Licence Number	L4247/1991/13
Licence Holder	Talison Lithium Australia Pty Ltd
ACN	139 401 308
Registered business address	Level 4 37 St Georges Terrace PERTH WA 6000
File Number	2012/007164
Premises	Talison Lithium Mine Mining Tenements M01/3, M01/6, M01/7 General Purpose Tenements G01/1 and G01/02 GREENBUSHES WA 6254
Date of Amendment	30 August 2017

Amendment

On 15 December 2016, Talison Lithium Australia submitted an application to amend their Licence L4247/1991/13 to authorise the installation and operation of an additional crusher and chemical grade lithium plant, with a capacity of 2.4 million tonnes per year. The crusher and plant would be located to the south of the existing processing plant, on a former tailings storage facility. An additional product storage bund (also referred to as the concentrate stockpile) will also be constructed to the east of the existing plant. Refer to Figure 1 for the proposed location of the new plant.

Figure 1: Indicative location of new crusher and processing plant

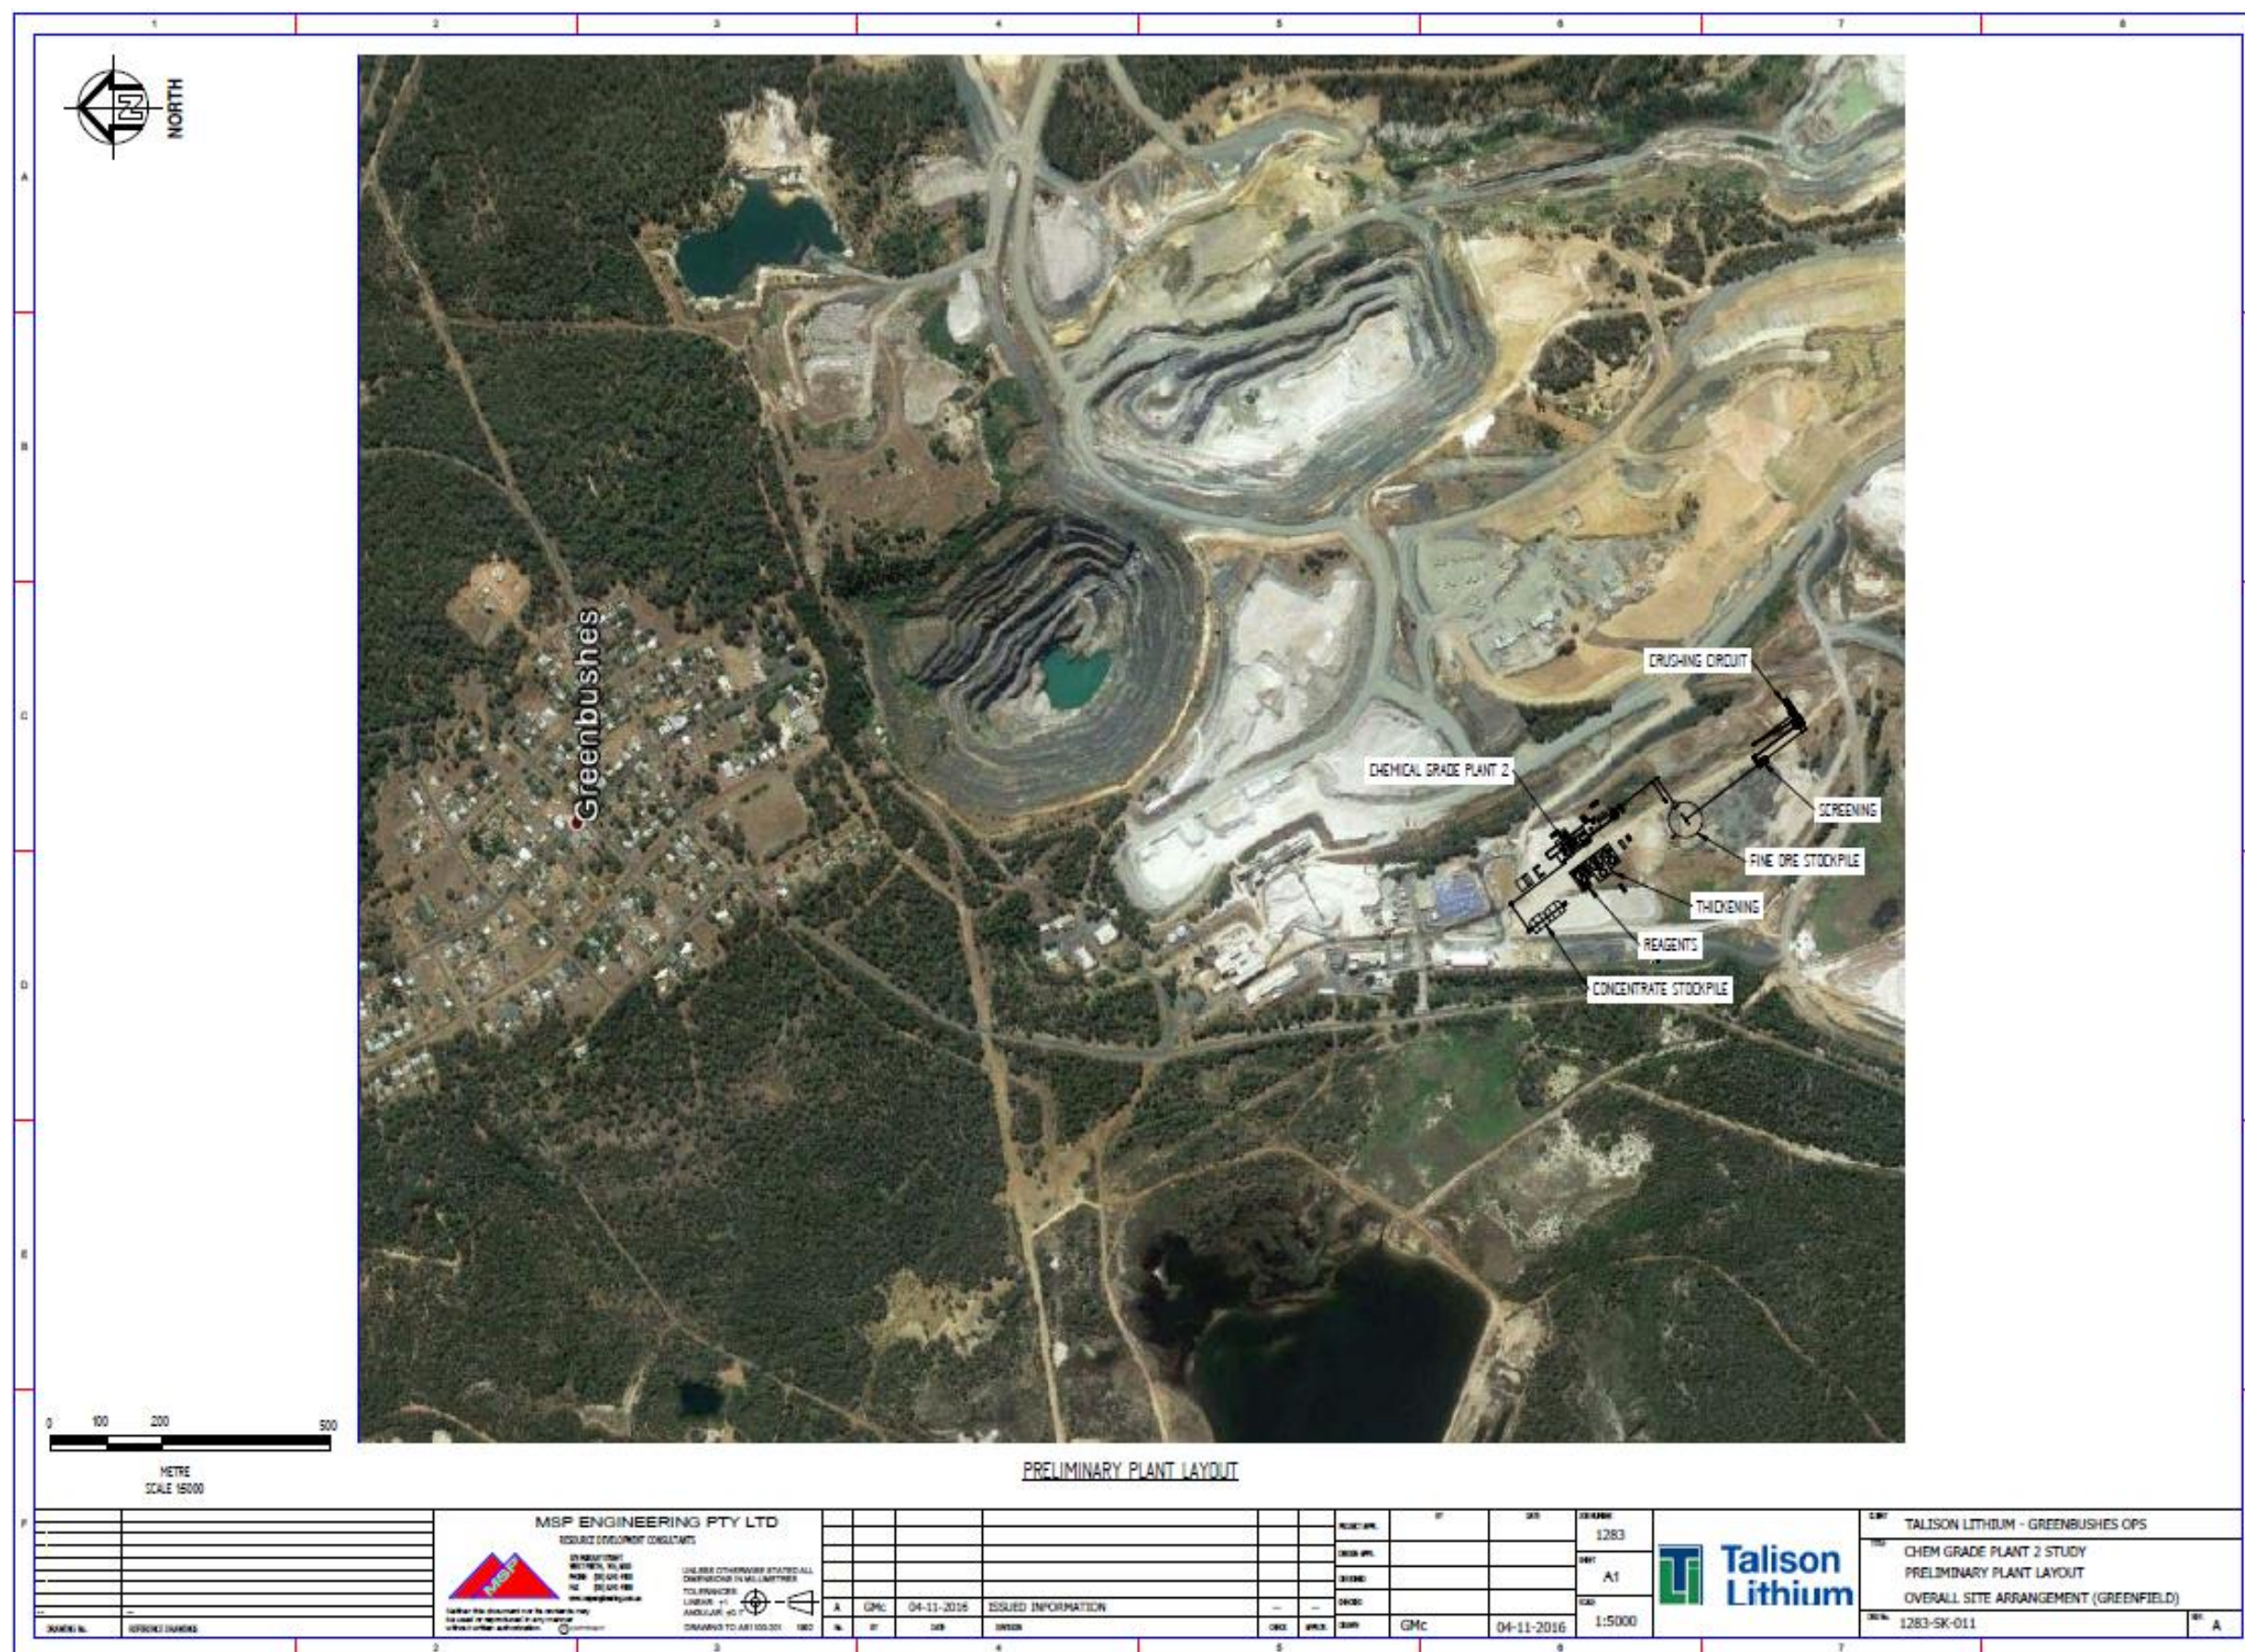
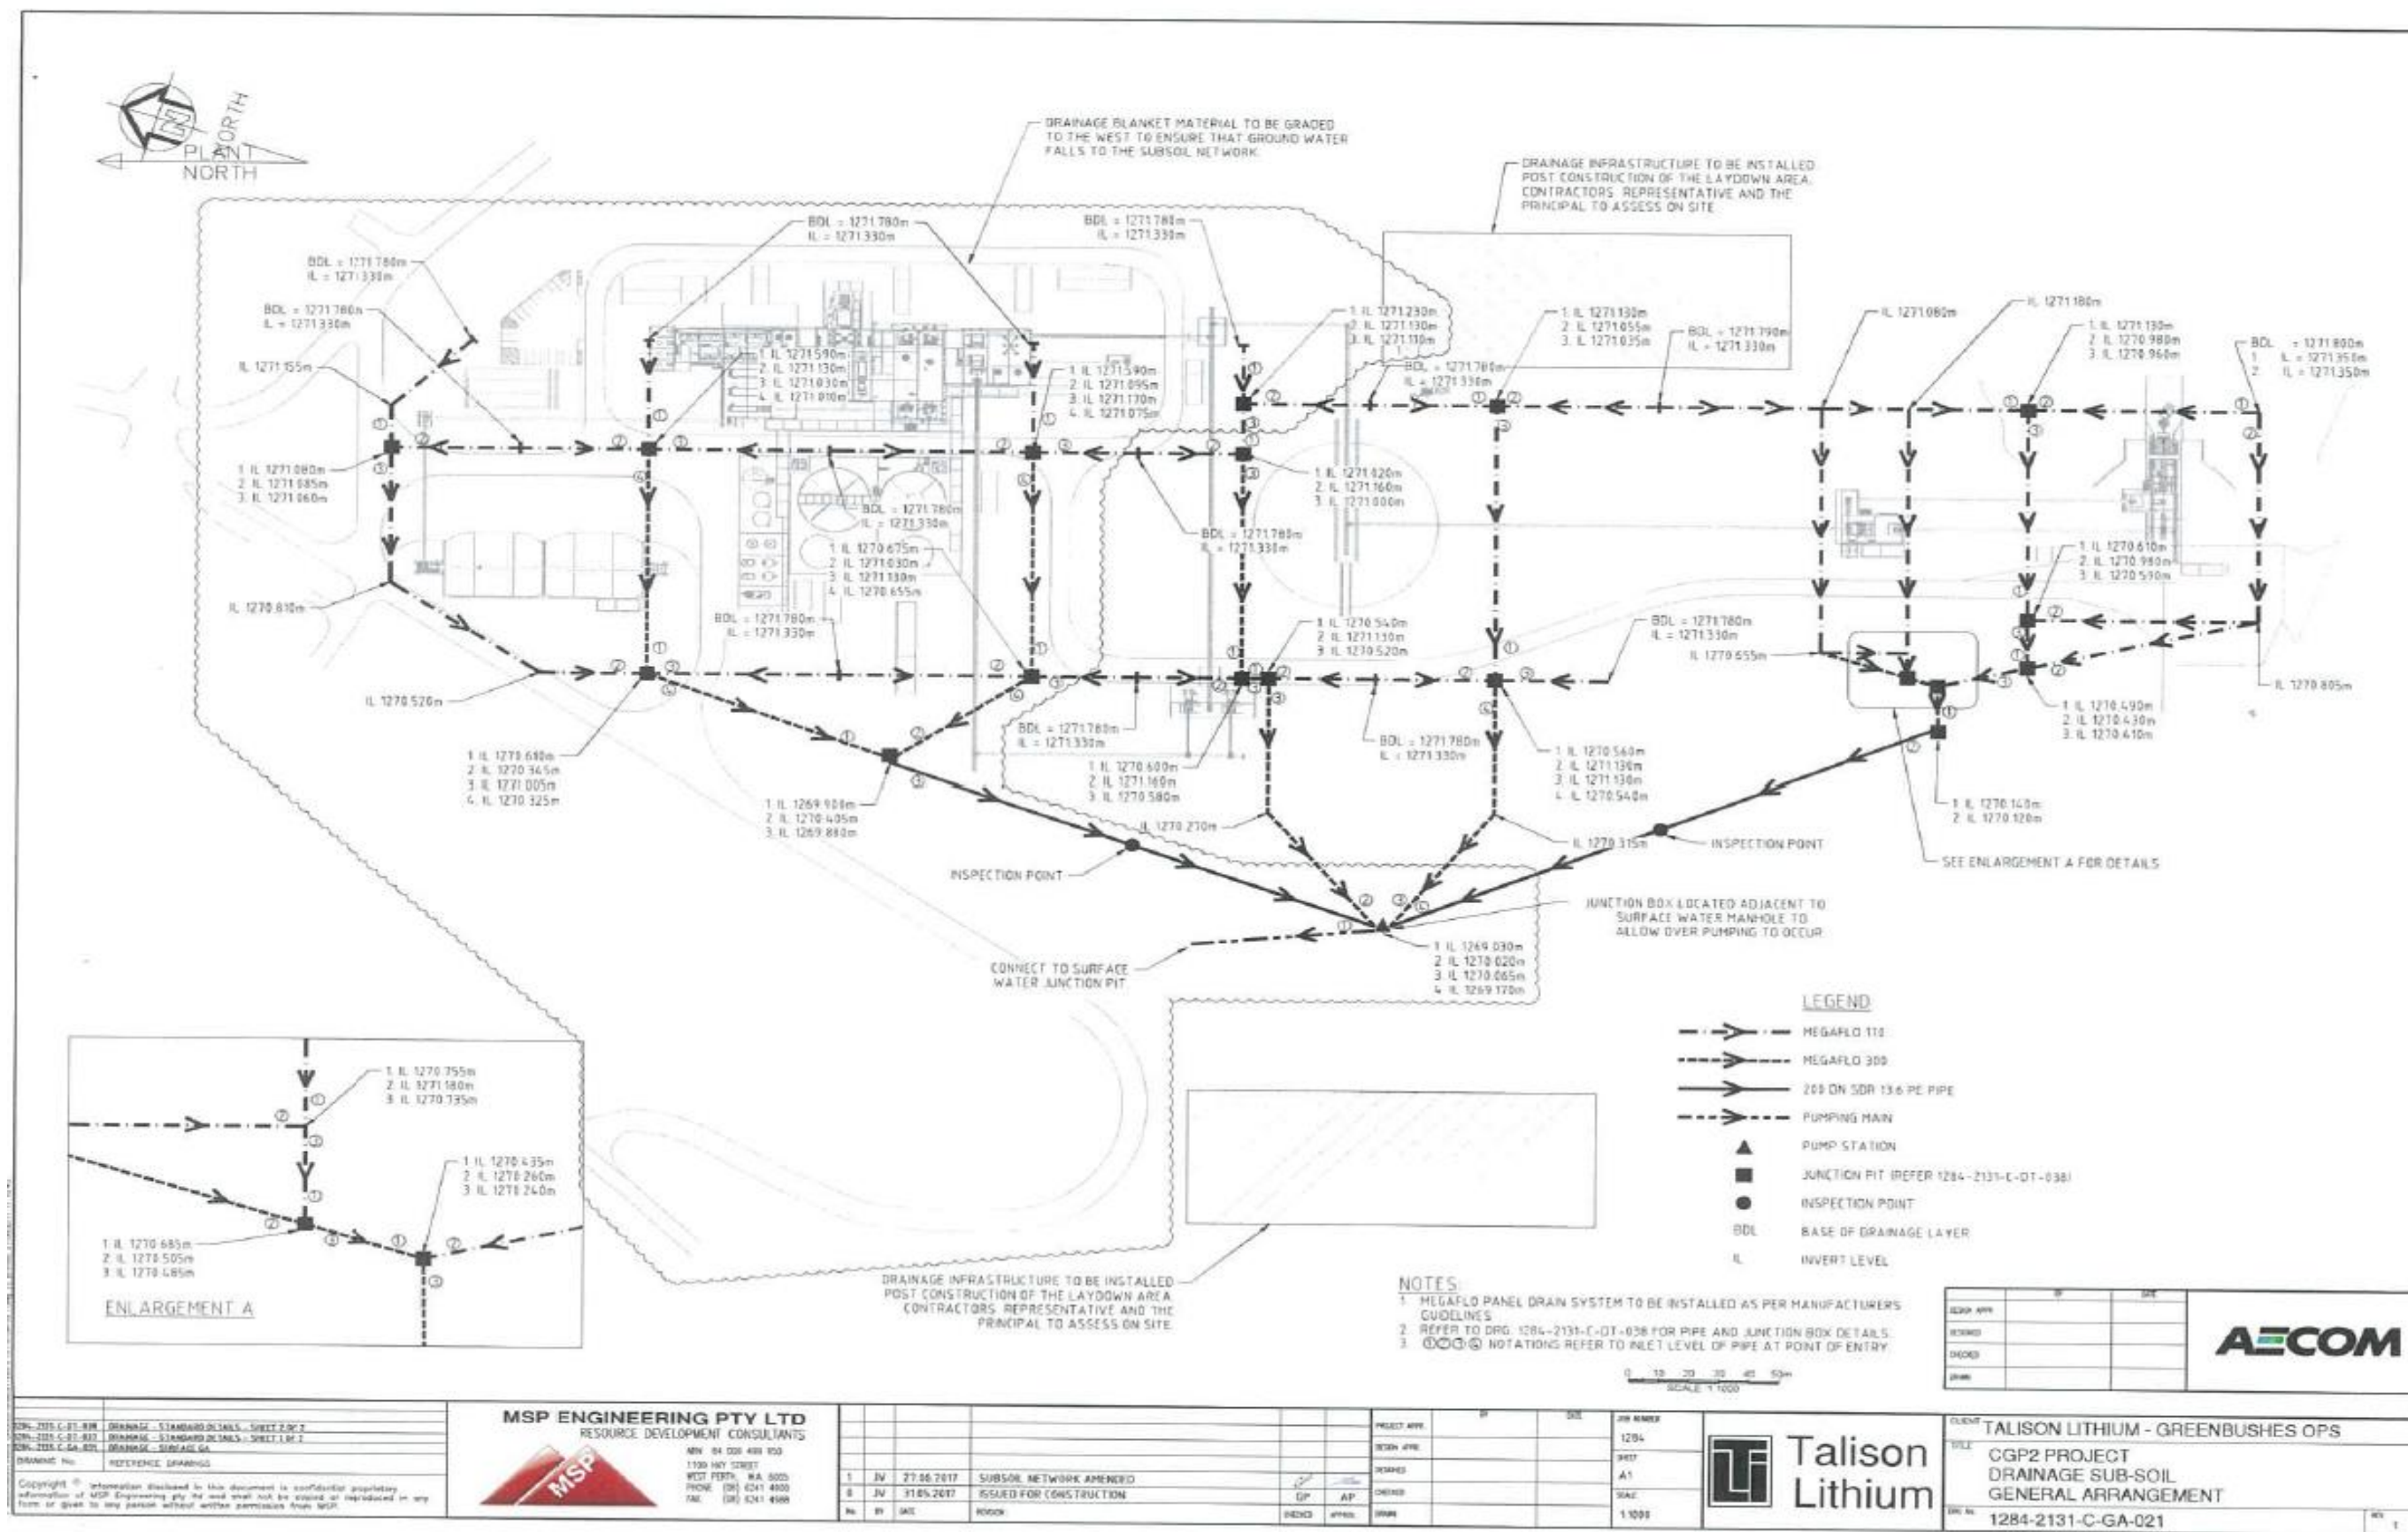
Amendment / Condition	Summary of Licence Holder comment	DWER response
Amendment, Figures 1 and 2	Updated figures supplied.	Included in amendment
Amendment, Table 11 (Risk Assessment) New Condition 1.3.12	Advised that general drainage from plant area is now directed to the wedge pits and the south west corner of the site and not to the TSF2.	Updated
Amendment, Section 1.5.5	Edit suggested to replace 'doubling' of seepage and decant flows with 'increasing' and a further edit to the sentence to remove 'increasing the' soluble lithium.	Accepted in part
Condition 1.3.1, Table 1.3.1	Request to include process water in the material authorised to be contained by Cornwall North Pit.	Accepted
Condition 3.3.1, Table 3.3.1	Request to add a footnote to clarify when monitoring is required of overflows from new siltation trap	Accepted
New Condition 1.3.11, Table 1.3.7	Edits required to the controls on the TSF pipeline; noted that the flow from the siltation trap (wedge pits) is gravity flow so valving and flow meters will not be installed; and that the overflow volume from the wedge pit would not be able to be recorded as it would be as gravity flow – an overflow alarm would be able to be installed.	Updated for pipelines, overflow alarm for wedge pit retained.

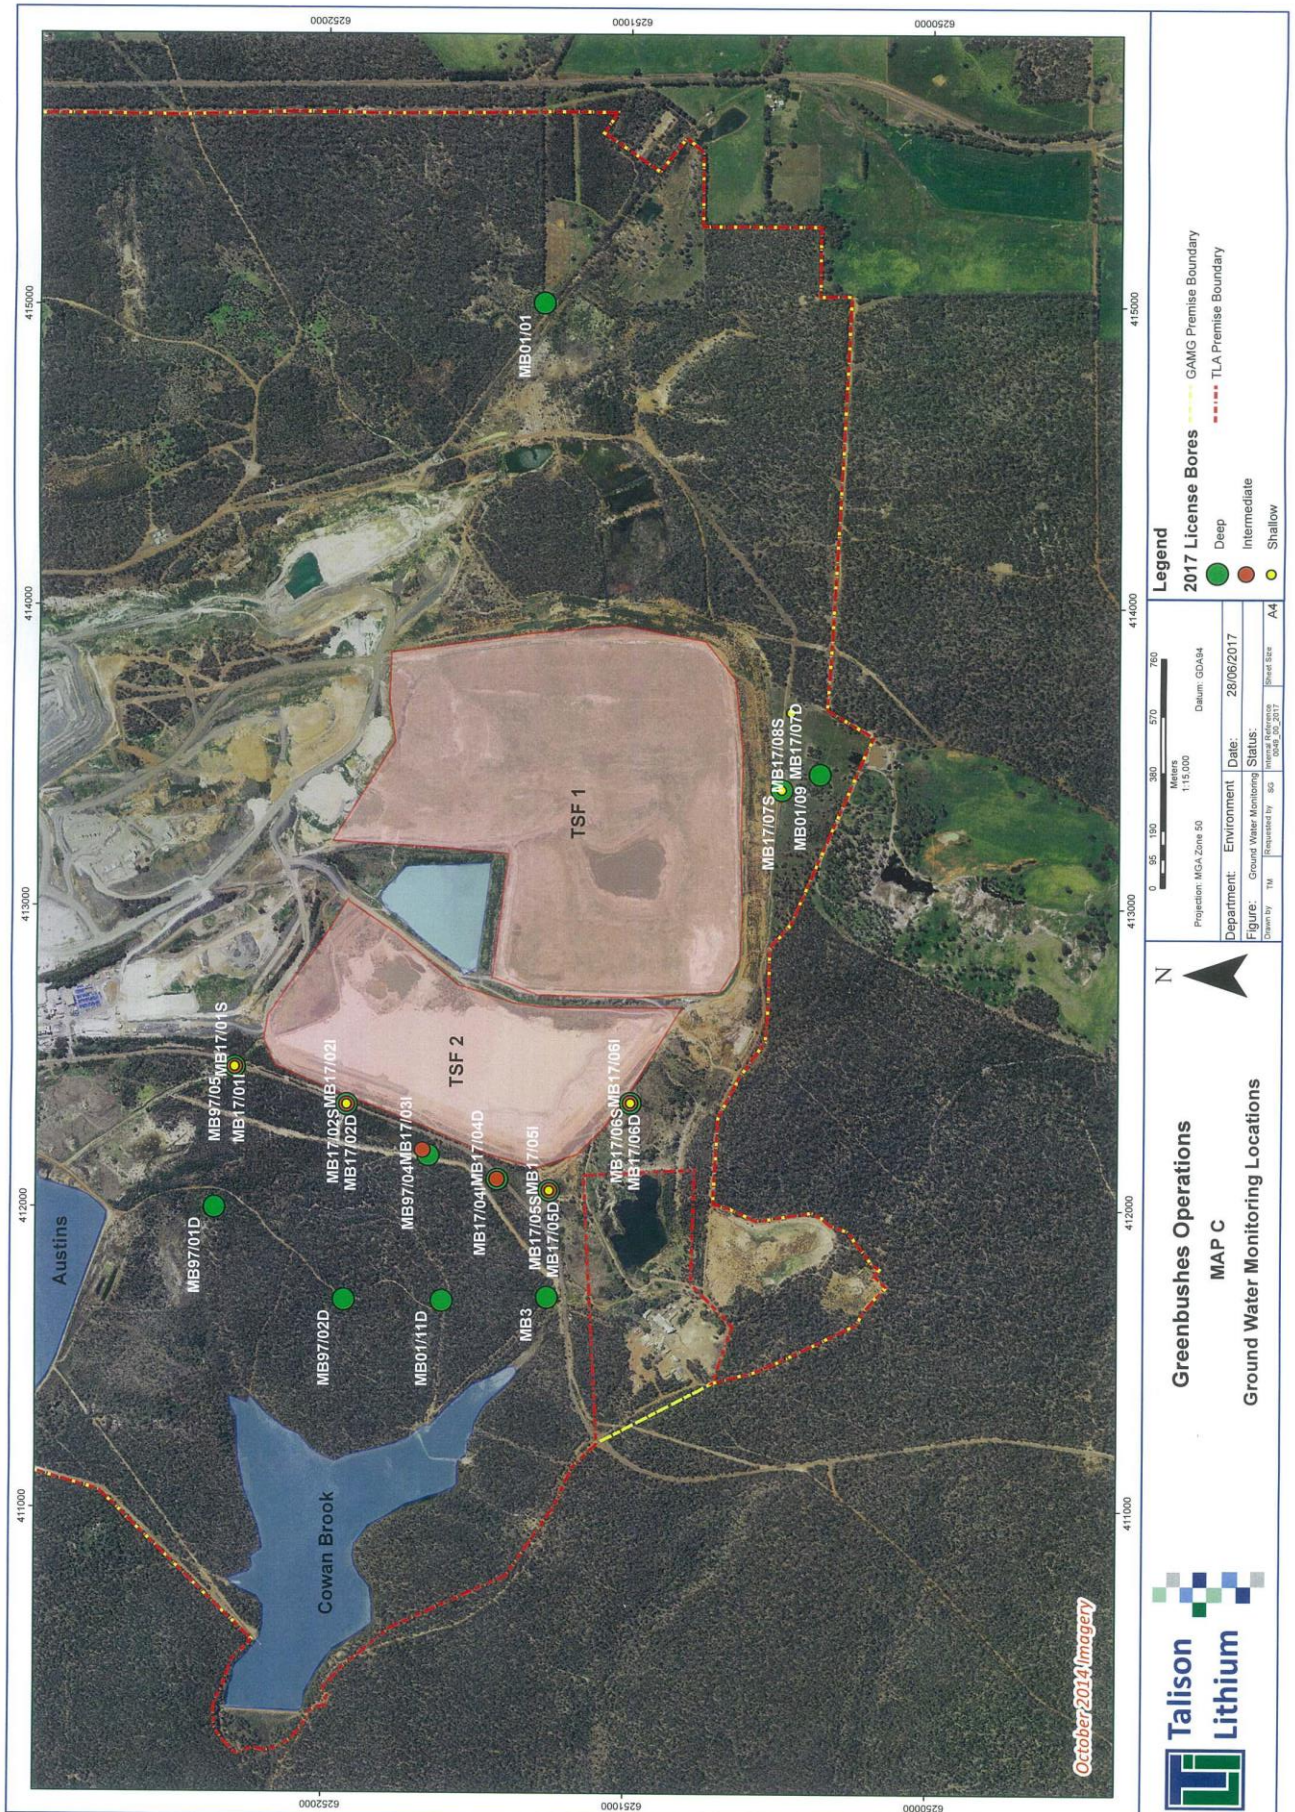
On 27 June 2017, Talison notified DWER that following drilling of the groundwater bores in 2017 they wished to change the notation for the new groundwater bores, remove proposed bores where no surface aquifer was present and also make corrections to listing of existing bores. Accordingly Talison requests Table 3.4.3 and Figure 3 of Schedule 1 of the current Licence to be updated.

9. Figure 3 of Schedule 1 of the Licence is replaced by the Figure below:
